1 Delegated Report		Analysis sheet	Expiry Date:	23/04/2025
		N/A	Consultation Expiry Date:	29/03/2025
Officer			Application Number(s)	
Matthew Kitchener			2025/0835/P 2025/0877/A	
Application Address			Drawing Numbers	
Outside No. 5-11 Procter Street and Junction of Catton Street London Borough of Camden WC1V 6NX			See draft decision notice	
PO 3/4	Area Team Signature	C&UD	Authorised Officer Signature	
Proposal(s)				
1. Removal of an existing InLink Unit, and the deployment of a replacement Street Hub 3 unit. 2. Advertisement consent: Removal of an existing InLink Unit, and the deployment of a replacement Street Hub 3 unit with 2 x digital advertisement panels.				
Recommendation(s):		1. Refuse planning permission 2. Refuse advertisement consent		
Application Type:		1. Full Planning Application 2. Advertisement Consent

1.0. Proposal

1.1 Planning permission and advertisement consent are sought for the removal of an existing InLink Unit, and the deployment of a replacement Street Hub 3 unit.

Image 3:

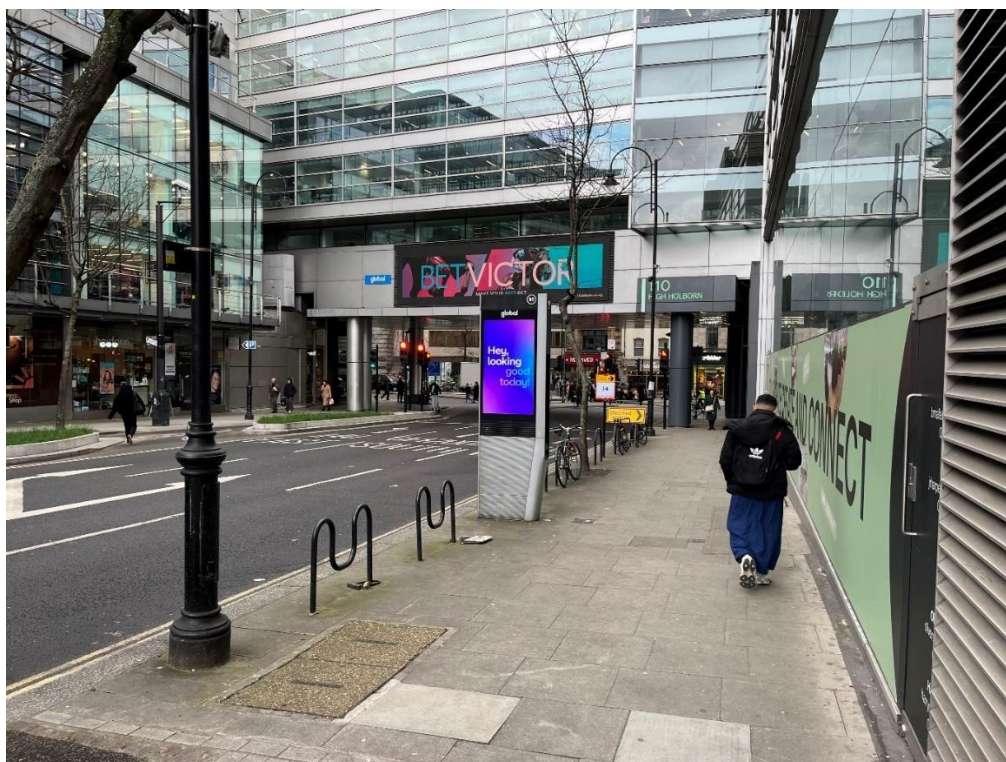
2.8 The main change with the hub structure is an increase in scale to allow the inclusion of a 6-sheet advertisement, which is a more standard design. It is considered to be poor in design terms and appears to have been primarily designed around the inclusion of two large digital screens on each of the main elevations. It would seem from the images of the proposed hub included within the application submission (see Images 1 and 2 above) that the size of the hub unit itself has been determined by the dimensions of the advertising panels. As such, the two illuminated digital advertising display screens occupy the majority of area available on each elevation of the structure (facing north and south along Procter Street respectively).

- 2.10 However, this has not been the case and the design approach has resulted in the creation of a large monolithic structure which gives the overall appearance as a large free-standing, advertisement panel rather than a structure for any other purpose.

- 2.11 The proposed hub would be located on the site of the existing In-Link hub, although the current hub is smaller in width and height. It is located in the middle of a section of cycle racks. The current hub is monolithic in design and appearance and is not considered to add positive visual interest to the streetscene, Indeed it's very nature is non-permeable in appearance and this adds to highlight its presence.

- 2.12 It is considered that its replacement with an even larger hub would add to this sense of a monolithic presence within the public realm and remove the permeability from this area of Procter Street where the low height of the existing cycle racks help reduce the presence of street furniture.

- 2.32 The stretch of pavement in the area of the application site is characterised by a footway width of 4.0m. The proposed new unit would be 347mm wider than the existing unit (measuring 1236mm wide compared to the existing unit at 889mm) and so would protrude slightly further into the area of free footway past the site. The proposed BT Street Hub 3 unit would leave a footway width of approximately 2.5m.

- 2.33 The close proximity of the application site to the highway, and introduction of a hub structure which significantly wider than any other existing furniture or features within this locality, raises concern as it would encroach onto the public highway and introduce an obstruction to pedestrian movement.
